STAFF RECOMMENDATION 1102 Forrest Avenue December 21, 2016

Application: New construction-outbuilding
District: Lockeland Springs-East End Neighborhood Conservation Zoning Overlay
Council District: 06
Map and Parcel Number: 08309012500
Applicant: Jim O'Shea
Project Lead: Robin Zeigler robin.zeigler@nashville.gov

Description of Project: The applicant proposes an addition to an existing out building, zoned CS.

Site Plan

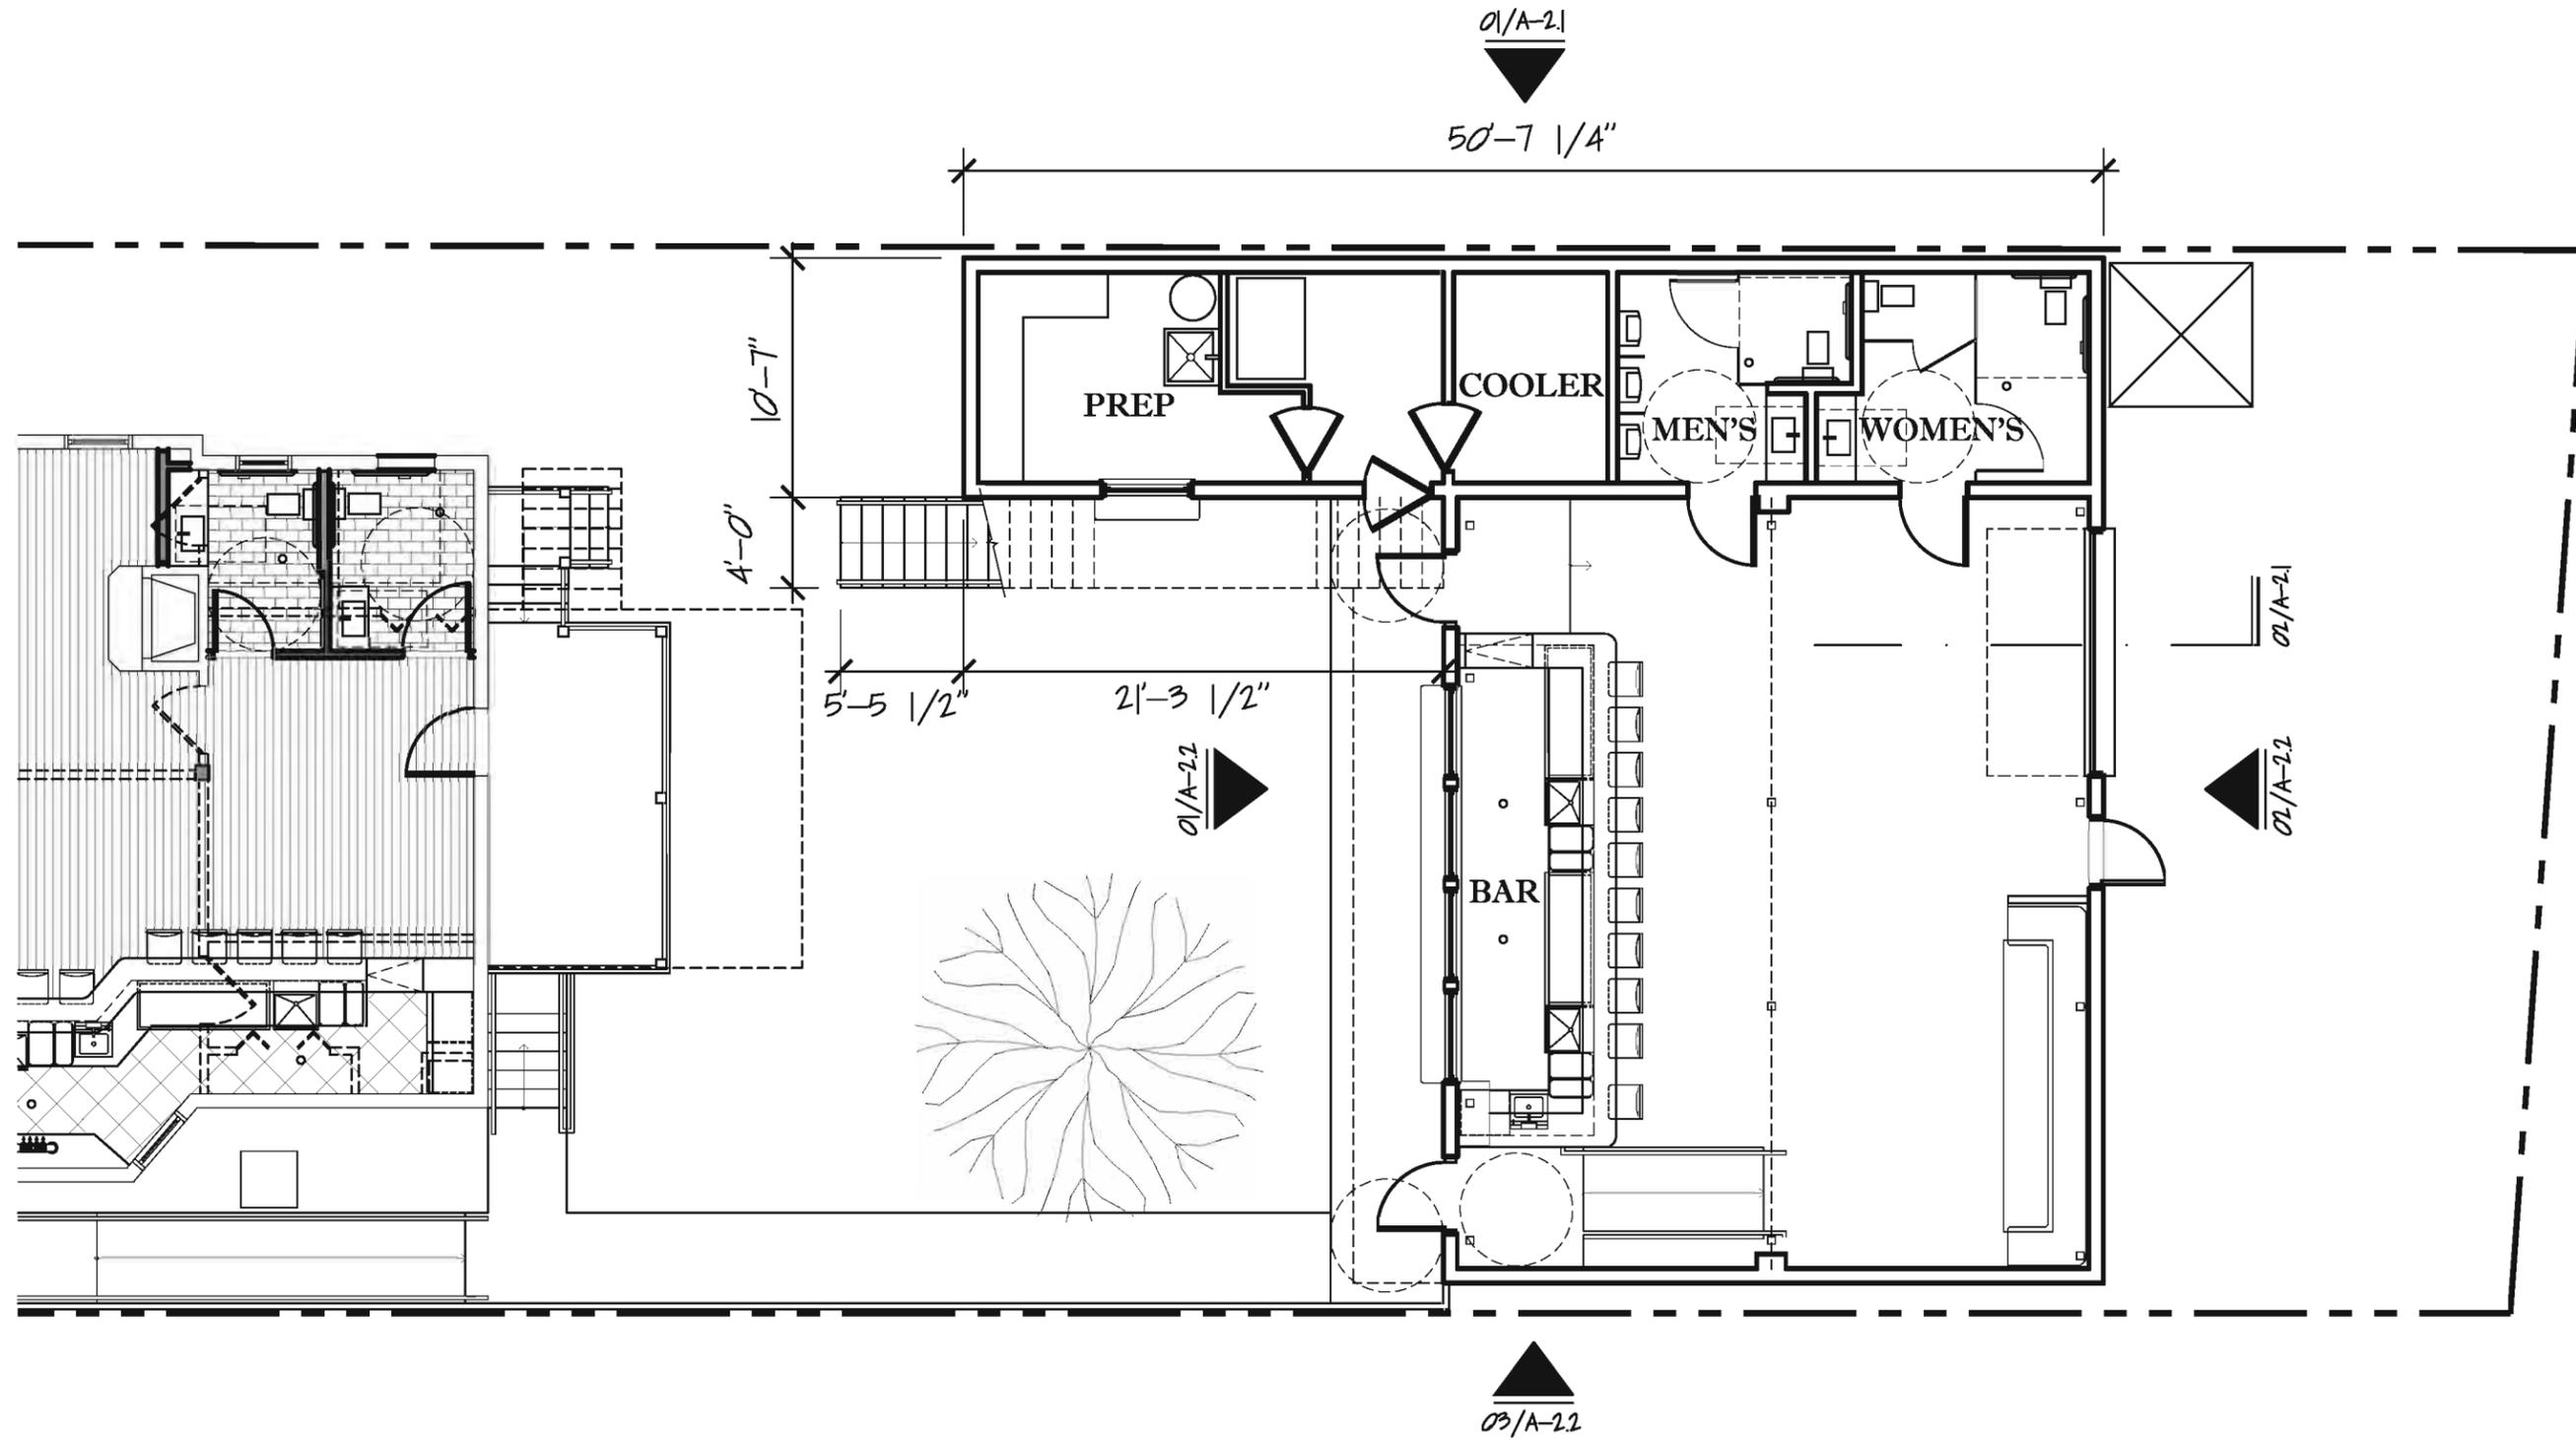
Location: Outbuildings are required to be at the rear of the lot, which this one is. The addition will not lessen the rear setback. The project meets II.B.8.b

Setback: CS zoning allows for 0 side setbacks. The right setback of one foot and four inches (1'4 1/8") is existing and will not change. The left setback will change from approximately ten feet (9' 11/8") to five inches (5"). No setback determination is required. The project meets section II.B.8.b.

02 Building Section

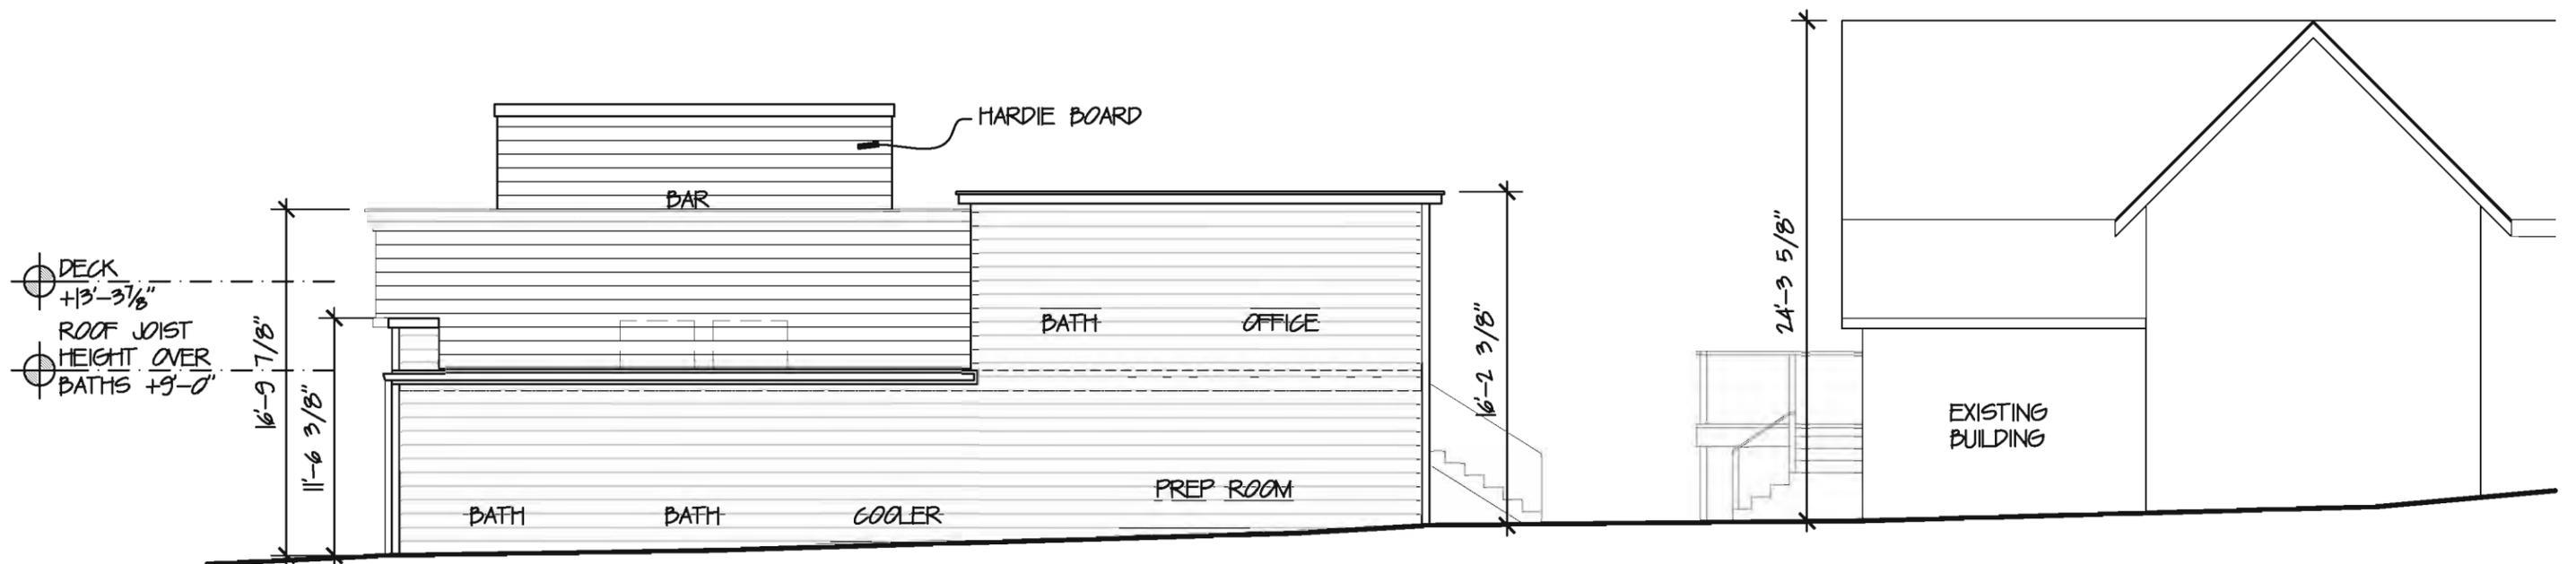
Height & Scale: The proposed addition to the outbuilding includes a roof deck over the original footprint of 1035 square feet and two levels in the area where the footprint has increase by approximately 512 sq ft. The main massing is shown as sixteen feet and two inches (16' 2 3/8") tall from grade with a partial second level that includes a covered bar and conditioned space that is twenty one feet (21') from grade, at its tallest point. The original building may have been approximately twelve feet (12') tall. Typically outbuildings should not exceed twenty four feet in (24') height with eaves that are less than the existing house and should not exceed the number of stories of the principle building, which is one-story. Because of the large footprint (see next paragraph) of the proposed and because of the flat roof (lack of eaves), staff recommends that the outbuilding not exceed one-level and sixteen feet (16') in height.

With the condition that the building not exceed sixteen feet (16') in height and that the outbuilding's footprint not exceed a thousand and five hundred square feet (1550 sq ft), staff finds the project meets section II.B.8.a.
